Product change information (PCN)

| PCN No.: | CBF190073 | Date: | 24.06.2019 |
| Product: | HEAVYCON module carrier frame | | |

Previous / new production status

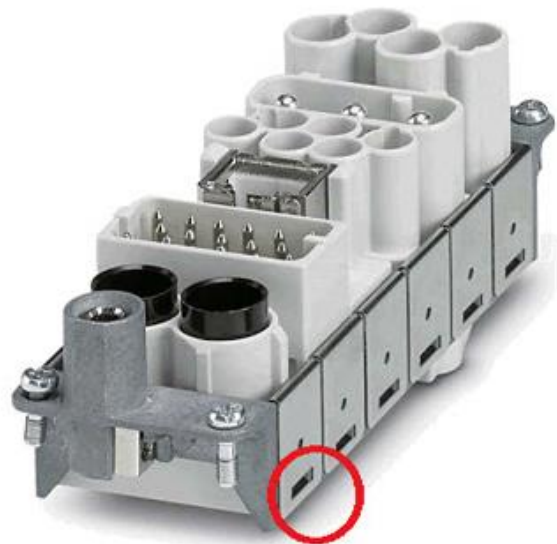
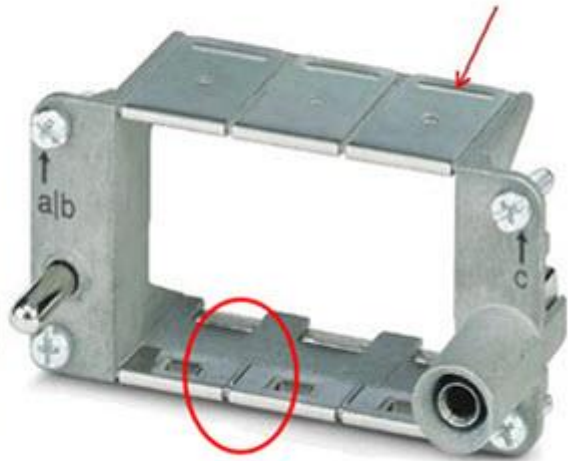
Changes to the retention springs on the module carrier frame

The stainless steel springs used to secure the modular HEAVYCON contact inserts will be modified. The springs will be designed as individual springs. Furthermore, the retention window for securing the contact insert modules will be reduced. This will ensure that the contact insert modules are more tightly secured in the module carrier frame.
